SUBJECT: Grand Avenue Bike Lanes

Grand Avenue Road Diet Elwood Ave. to Jean St.

Project: Grand Avenue Road Diet

Subject: Response to Public Comments

**Grand Avenue
Road Diet**
Typical cross-section
Elwood Ave. to Jean St.

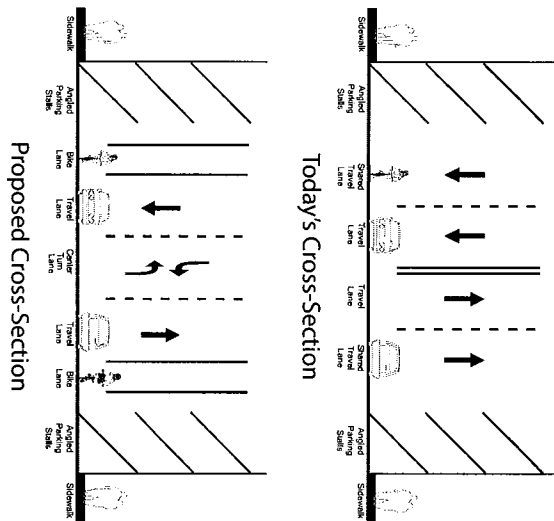
3. Eighteen respondents want a protected bike lane (a bike lane between parked cars and the sidewalk) rather than a traditional bike lane.

10. Five respondents prefer parallel parking to accommodate a protected bike lane.

- The street's right-of-way width is likely not wide enough to provide sufficient space for a protected bicycle lane. The vehicle travel lane would need to be widened if the bicycle lane was relocated between the parking and the sidewalk in order to allow for safe and efficient entry and exit from the parking stalls. This extra travel lane width would likely result in a protected bicycle lane of insufficient width.

There is a 3 foot buffer provided on the curb side of the 5 foot bicycle lane (between parked cars and people on bicycles). This will provide additional separation between bicyclists and parked vehicles.

Figure 1: Illustration of Multiple Threat

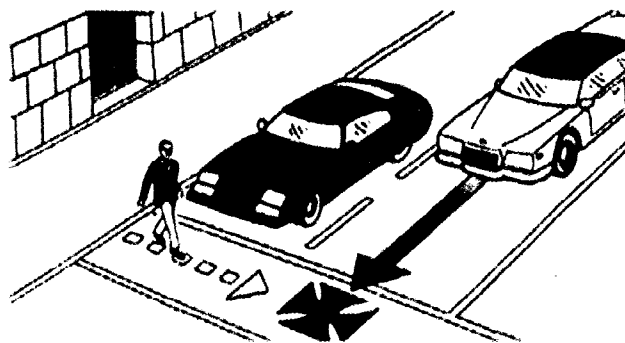
6. Nine respondents expressed a desire for additional pedestrian safety measures; including Rapid Flashing Beacons (push button controlled flashing lights at midblock crosswalks).

Rapid flashing beacons are not part of the proposed project at this time as the road diet incorporates many improvements for pedestrians:

- Fewer vehicle travel lanes to cross and the ability to cross the street in two stages
- Enhanced visibility for pedestrians crossing Grand Avenue
- Lower speeds on the corridor, increasing motorists' sight distance and stopping ability.
- Elimination of the "multiple threat" depicted in Figure 1.

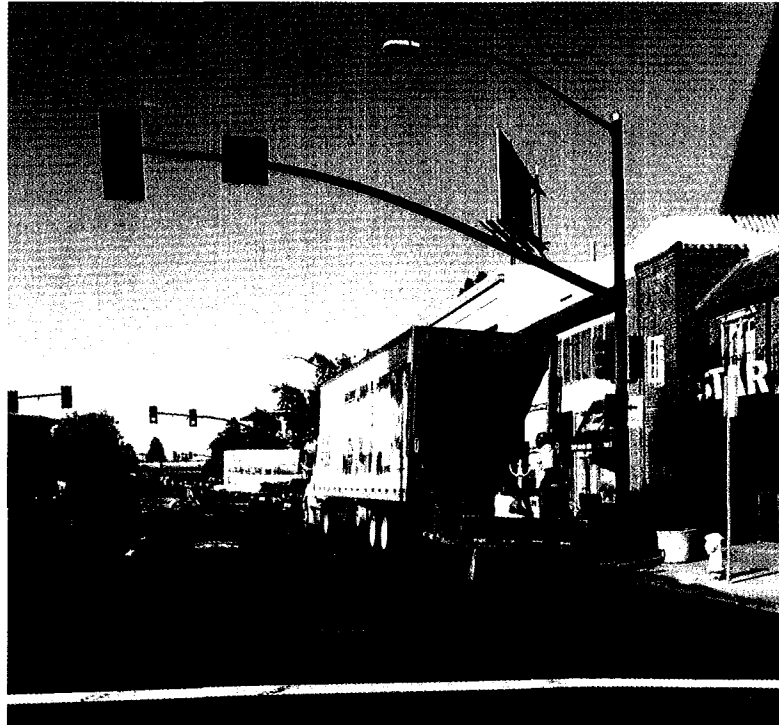
7. Nine respondents expressed concern about drivers potentially diverting to Walker Avenue to traverse the corridor.

Research from the Federal Highway Administration has shown that side street diversions will likely not be prevalent on Grand Avenue, which carries about 16,500 vehicles per day:

Under most annual average daily traffic (AADT) conditions tested, road diets appeared to have minimal effects on vehicle capacity because left-turning vehicles were moved into a common two-way left-turn lane (TWLTL). However, for road diets with AADTs above approximately 20,000 vehicles, there is an increased likelihood that traffic congestion will increase to the point of diverting traffic to alternative routes.¹

With Grand Avenue specifically, a diversion study on Walker Avenue was performed to determine what the likelihood of diversion. This study showed that even with the implementation of the proposed road diet, Grand Avenue was still faster than diverting to Walker Avenue. Details of this study can be found on the Project's webpage.
